**From:** Brian Tracey <Brian\_Tracey@genpower.net>  
**To:** Peter Courtney <Peter.Courtney@dnr.state.ga.us>  
**CC:** "tyneshia.tate@dnr.state.ga.us" <tyneshia.tate@dnr.state.ga.us>  
**Date:** 6/11/2010 5:43 PM  
**Subject:** RE: Yellow Pine Energy Company, SIP Application 19518, AIRS:06100001 - air dispersion modeling information  
**Attachments:** 100611 YPE\_PSD\_Response\_to\_EPD\_Comments.pdf

**Subject: Response to EPD Comments  
Revised Air Dispersion Modeling Analysis  
PSD Permit Application  
Yellow Pine Energy, LLC  
Clay County, GA**

Yellow Pine Energy  
 Clay County, Georgia  
 Revised: 06/10/2010

Figure 2.  
 Site Layout and Building Inputs

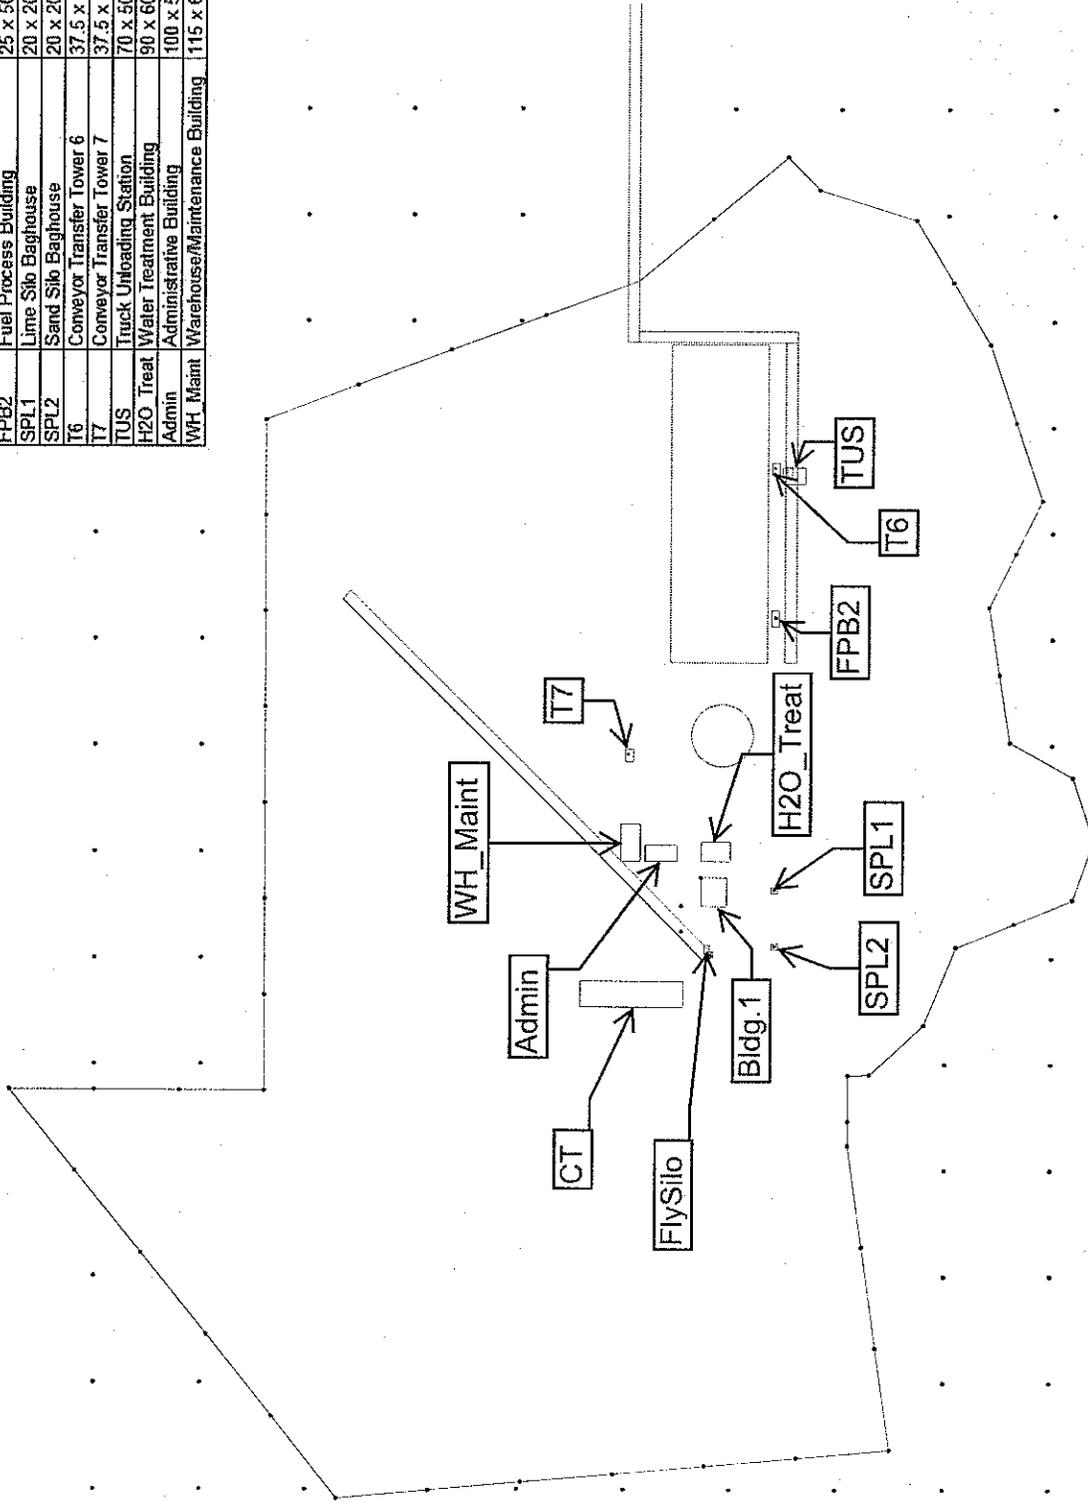
**GA EPD Comment No. 2** - I have located in pencil on the attached site source plot the only building I find represented in any model. It seems to me that the building is distant from the main boiler stack, or that another building which houses the main boiler should be closer to the main boiler stack. It is possible, without seeing a detailed site plan at a legible scale, that there may be other structures which could cause downwash effects and should be represented in the models. It is not uncommon for both the main boiler and the auxiliary boiler to be housed in separate (sizeable) structures. Other structures may be proposed for the site, such as baghouses, cooling towers, fugitive source-supporting towers, silos, etc. A portion of the site plan with a useable scale should be provided that clearly shows the locations and heights of any other structures which could influence the air quality impacts by creating downwash effects.

The revised dispersion modeling analysis also accounted for the following changes to the CFB Boiler stack location, boiler structure location, and site layout changes:

- Revised boiler stack location and an increase in stack base elevation of approximately 28 feet to 198 feet above mean sea level.
- Revised CFB boiler structure location to a position adjacent to the boiler stack location and consistent with the boiler structure layout. For the purpose of this modeling analysis, the Auxiliary boiler was assumed to be adjacent to the CFB boiler structure and therefore no downwash effects would be created by an Auxiliary boiler structure.

- Revised site layout, as provided by YPE. The attached Figure 1 illustrates the layout of the facility emission sources for truck delivery operations as inputs to the dispersion model. The attached Figure 2 illustrates structures that were added to the revised modeling analysis in response to GA EPD comments. This includes the addition of the following structures: cooling tower, fly ash silo, sand silo, lime silo, boiler structure, water treatment building, administrative building, warehouse/maintenance building, conveyor transfer towers for T6 and T7, fuel processing building, and the truck receiving building.
